**Summary of Changes  
ITS Section 3.0**

### **KEWAUNEE POWER STATION IMPROVED TECHNICAL SPECIFICATIONS CONVERSION**

#### **ITS SECTION 3.0 LCO AND SR APPLICABILITY**

##### **Revision 1**

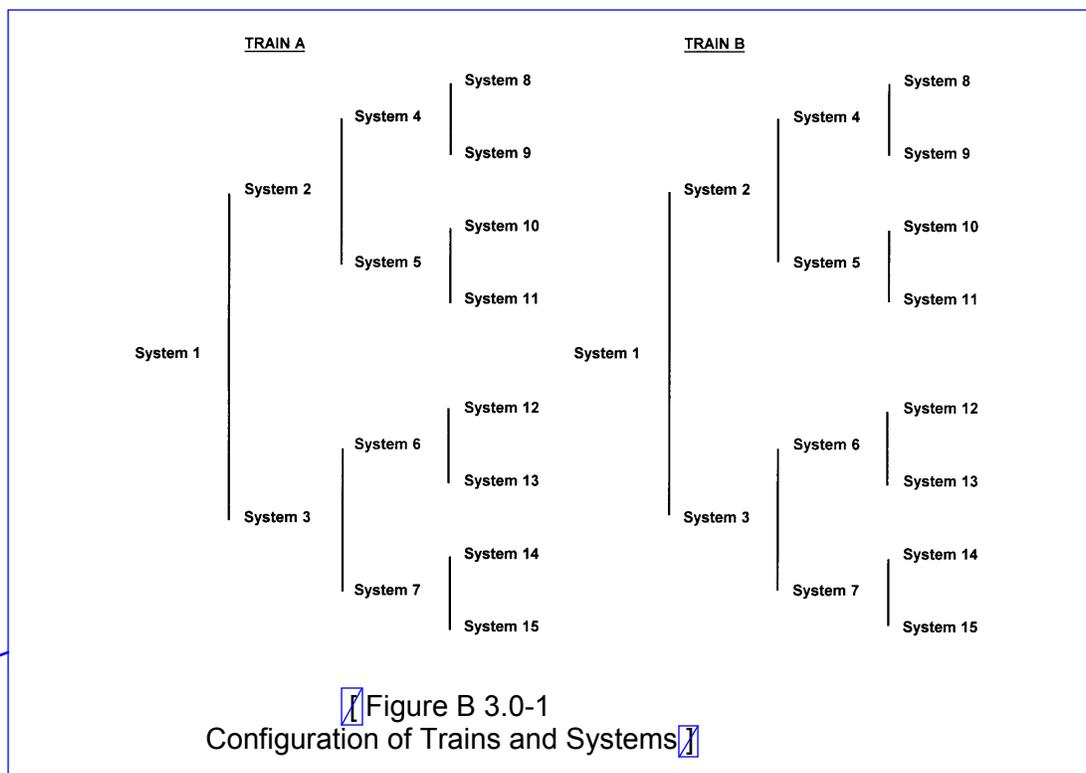
3. The ISTS Figure B 3.0-1 is located within the text portion of LCO 3.0.6. The typical configuration for locations of figures is at the end of the applicable section. The figure is relocated to the end of the LCO section for 3.0. This is acceptable since the relocation of the figure to the end of the section is in accordance with the format of the ITS.

1) Example B 3.0.6-1 is changed from "If System 2 of Train A is inoperable and System 5 of Train B is inoperable, a loss of safety function exists in supported System 5" to "If System 2 of Train A is inoperable and System 5 of Train B is inoperable, a loss of safety function exists in Systems 5, 10, and 11." Examining Figure B 3.0-1, it is clear that if there is a loss of safety function in System 5, there is also a loss of safety function in the systems supported by System 5, i.e., Systems 10 and 11. This relationship is explicitly listed in Example B 3.0.6-3 and to not do so here is inconsistent and confusing as it leads the reader to believe that Systems 10 and 11 do not have a loss of safety function. Furthermore, System 5 of Train B is not a supported System of System 2 of Train A, since they are in different trains. Thus, the word "supported" has been deleted.
